Amphenol PCD

Engineering Change Request		ECR Number	R10200W	
Initiator:	Holiday	Date:	2026.04.17	
Part number description				
Item	K3 Code material part numbers	Drawing/ Doc Number	Version of current related document	New Version
1	HVSL282系列	C- HVSL282022X	K	N/A
2		C- HVSL282022X-ND	E	N/A
Reason of change:				
<input type="checkbox"/> Customer requirement (list the feasibility analysis of customer specification: _____)				
<input type="checkbox"/> Supplier request (list the PCR number: _____)				
<input checked="" type="checkbox"/> internal improvement <input type="checkbox"/> corrective <input type="checkbox"/> other				
<u>Please describe here in detail:</u>				
<p>The HVSL282 socket series optimizes the oil-based sealing ring to prevent foreign matter from adhering to it. The sealing ring has been changed from self-lubricating to non-self-lubricating, which has no impact on the function or appearance of the finished product.</p>

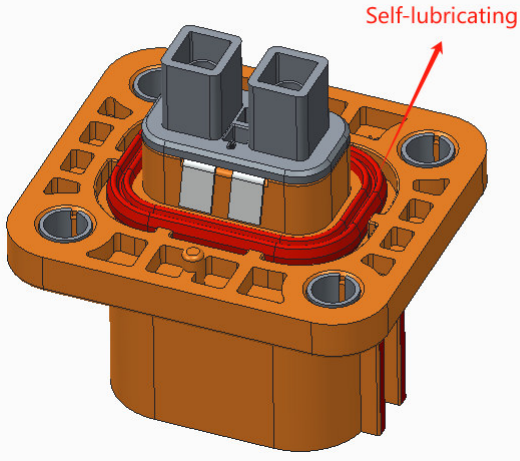
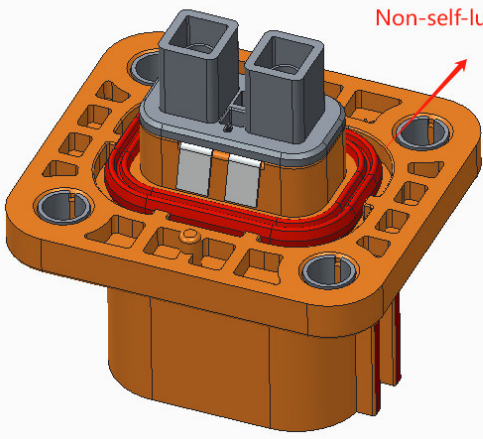
<p>Before change</p> <p>The panel sealing ring is a self-lubricating sealing ring.</p> 	<p>After change</p> <p>The panel seal has been changed to a non-self-lubricating seal, which will not contain silicone oil. The structure, appearance, and function remain unchanged.</p> 
<p>Disposition of old materials</p> <p> <input type="checkbox"/> Rework <input checked="" type="checkbox"/> Use as it is <input type="checkbox"/> scrap <input type="checkbox"/> Other (please describe): _____ <input type="checkbox"/> N/A </p>	<p>Expect date to switch to new material</p> <p><u>2026.06.30</u></p>
<p>Approval by the supervisor of requester.:</p> <p><i>Sentao</i> <i>Derek</i></p>	<p>Approval by the head manager of the request dept.:</p> <p><i>Changhong</i></p>
<p>Customer approval:</p> <p> <input type="checkbox"/> Approved <input type="checkbox"/> No approved <input type="checkbox"/> Conditional approval (please describe) : Signature: _____ Date: _____ </p>
